May 9, 2016

ND-16-0557
10 CFR 50.90
10 CFR 52.98

Southern Nuclear Operating Company
Vogtle Electric Generating Plant Units 3 and 4
Supplement to Request for License Amendment:
Wall 11 Changes (LAR-15-021S1)

**UFSAR Appendix 3H, Figure 3H.5-5, Sheet 1 of 3 [Concrete Reinforcement in Wall 11]* -
Revise information for the figure as shown below (complete figure) [Note 4 revised with
this supplement].**

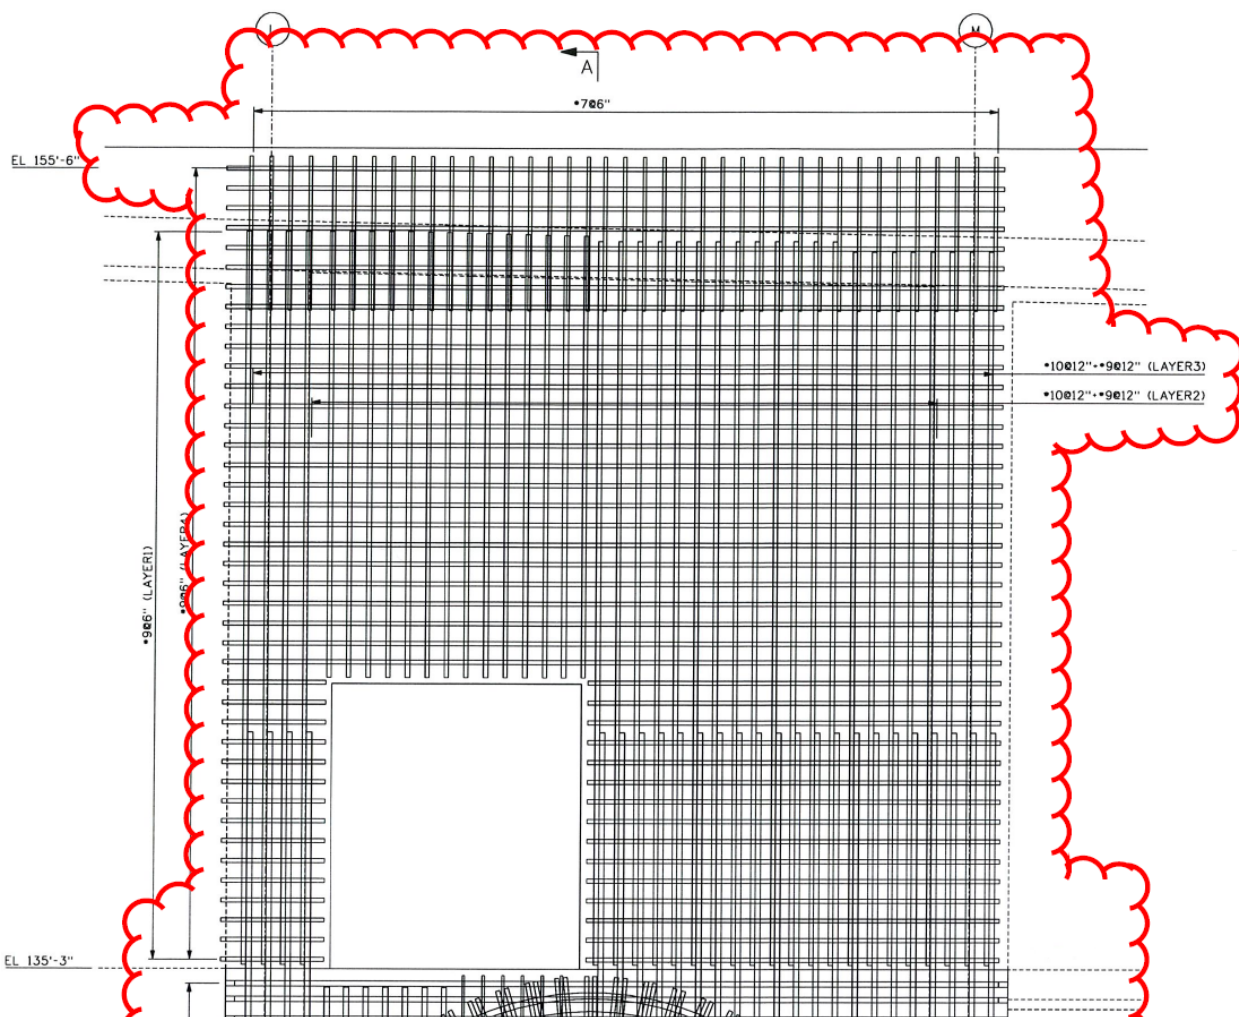
4. Figure 3H.5-5 (Sheets 1 and 3) is revised to remove the openings at elevation 148'-9" - 151'-6" and close the openings off with reinforced concrete consistent with the surrounding wall.

5. Figure 3H.5-5 (Sheets 1, 2, and 3) is revised to incorporate the changes to the reinforcement ~~design and details detailing and development~~ surrounding the main steam line penetration.

6. Notes are added to UFSAR Figure 3H.5-5, Sheet 1 to:
 - i. Identify that the figure depicts detail specific to Wall 11 between column lines L and M (east MSIV compartment), and subsection 3H.5.1.4 provides information concerning ~~design details variations in reinforcement detailing and development~~ applicable to the other wall section (west MSIV compartment).

8. UFSAR Figure 3H.5-5, Sheet 1 is revised to reflect a change in the design of the main steam line penetration sleeve headed studs. UFSAR Figure 3H.5-5, Sheet 3 is revised to reflect a change in the design of the main steam line penetration sleeve shear lugs and headed studs.
9. UFSAR Figure 3H.5-5, Sheet 2 is revised to remove references to the 2'-0" floor and the 117'-6" elevation, and identify the elevation of the bottom of the 4'-0" thick section of the wall as 115'-6" for clarity.

UFSAR Appendix 3H, Figure 3H.5-5, Sheet 1 of 3 [*Concrete Reinforcement in Wall 11*]* - Detailed view of the revised information for the upper portion of reinforcement.

UFSAR Appendix 3H, Figure 3H.5-5, Sheet 2 of 3 [Concrete Reinforcement Layers in Wall 11 (Looking East)]* - Revise information for the figure as shown below.

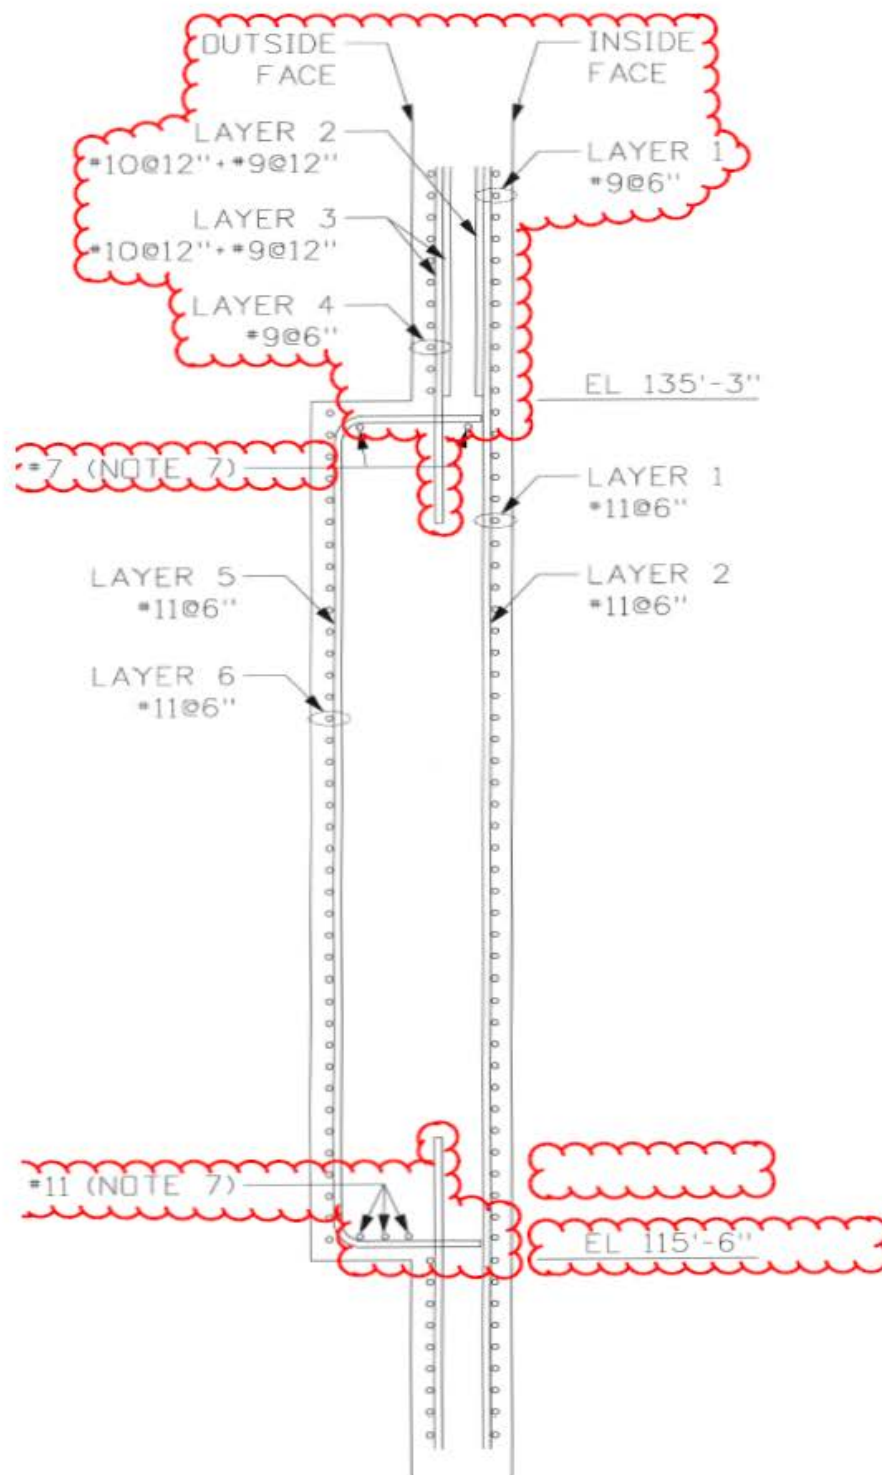
- The end configuration of Layer 5 shown on UFSAR Figure 3H.5-5, Sheet 2 is being changed from a non-standard 180 degree bend to a standard 90 degree hook with additional runout. This change is being made to provide improved cracking resistance at the transition of the 2 ft. wall section to the 4 ft. wall section.

UFSAR Appendix 3H, Figure 3H.5-5, Sheet 3 of 3 [Wall 11 at Main Steamline Anchor Section A-A]* - Detailed view of the revised information for the upper portion of the figure.

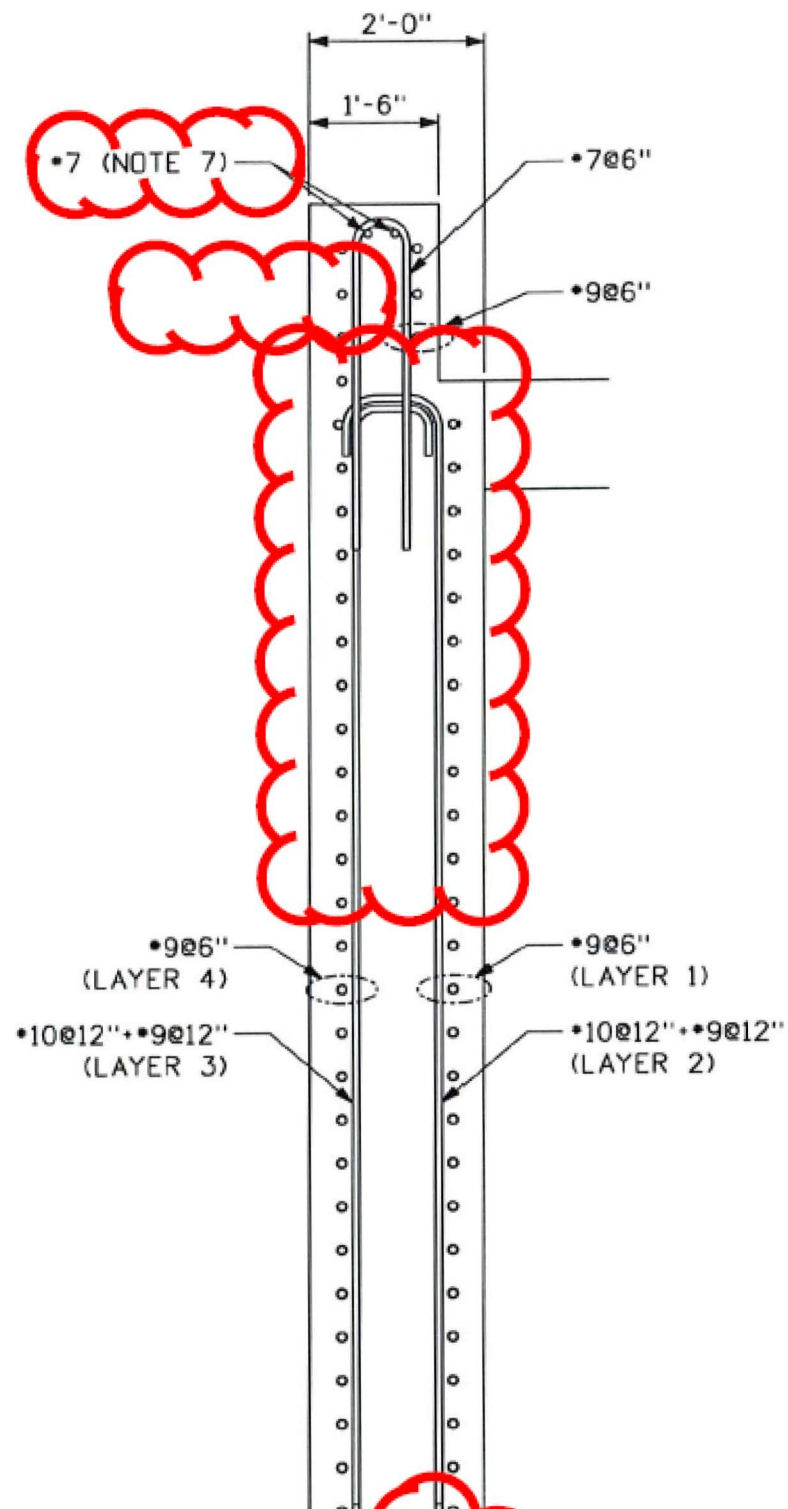
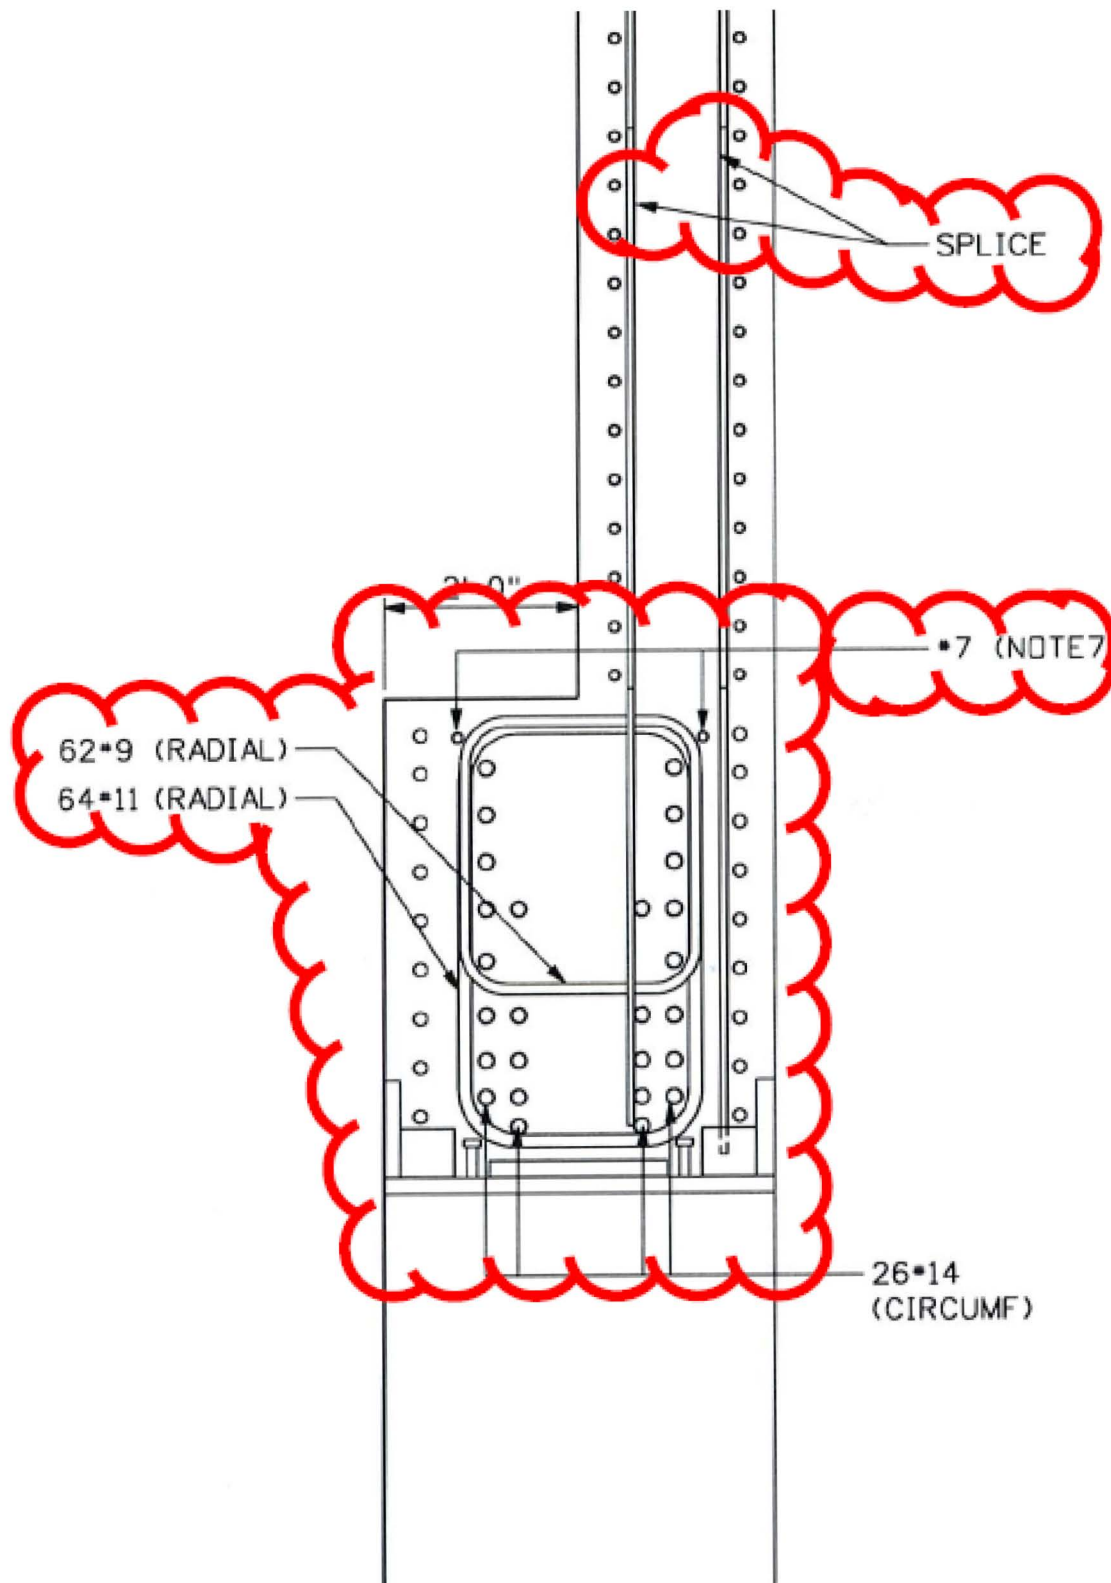
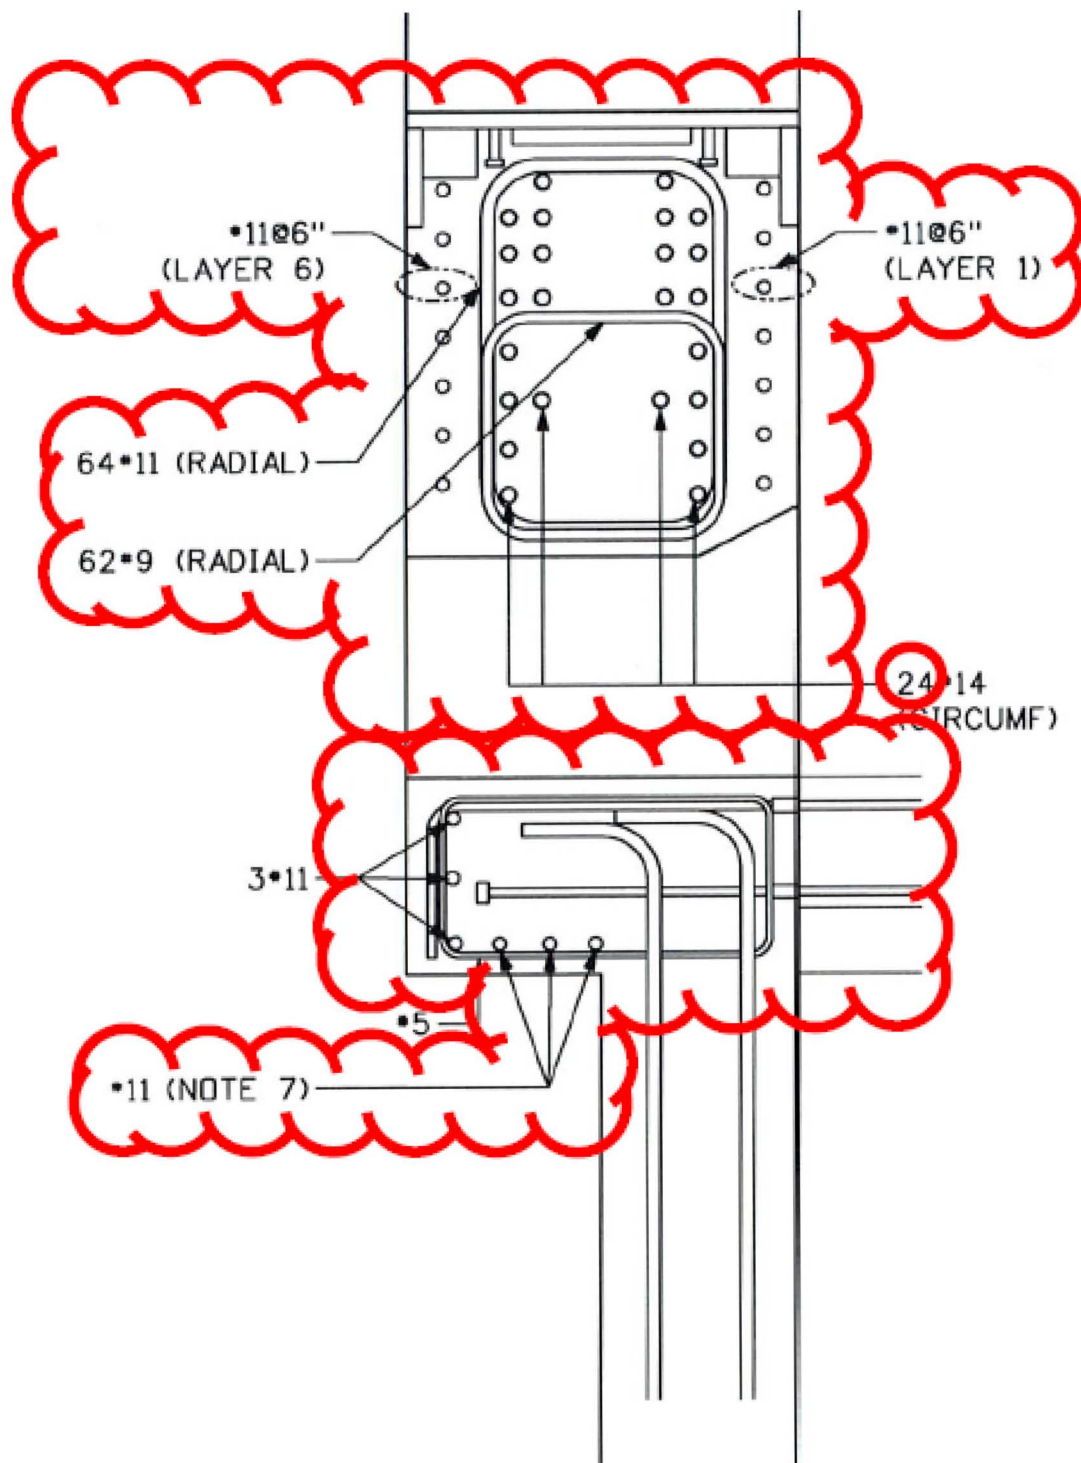
identified in Section 3 below under "Wall 11 ACI 349-01 Conformance Review." These changes are shown in UFSAR Figure 3H.5-5, Sheet 3. This figure has also been revised to show both the horizontal and circumferential reinforcement in the section.

11. The #5 hooked bar below the drain/vent openings below the main steam line penetrations and adjacent to the floor below elevation 117'-6" is modified to an enclosed hoop to meet development requirements of ACI 349-01 Section 12.2. See Review Item #8 identified in Section 3 below under "Wall 11 ACI 349-01 Conformance Review." This is shown in Figure 3H.5-5, Sheet 3.

12. Anchorage in the wall of the bottom horizontal bar from the floor slab below elevation 117' 6" is modified from a standard hook bent upward to a mechanical T-headed anchorage to provide for constructability. It was determined that a standard 90 degree hook configuration would not fit within the section. The bar with headed reinforcement satisfies the supplemental requirements for headed reinforcement identified in UFSAR subsection 3.8.4.4.1. See Review Item #10 identified in Section 3 below under "Wall 11 ACI 349-01 Conformance Review." This is shown in Figure 3H.5-5, Sheet 3.

UFSAR Appendix 3H, Figure 3H.5-5, Sheet 3 of 3 [Wall 11 at Main Steamline Anchor Section A-A]* - Detailed view of the revised information for the middle portion of the figure.

UFSAR Appendix 3H, Figure 3H.5-5, Sheet 3 of 3 [Wall 11 at Main Steamline Anchor Section A-A]* - Detailed view of the revised information for the lower portion of the figure.
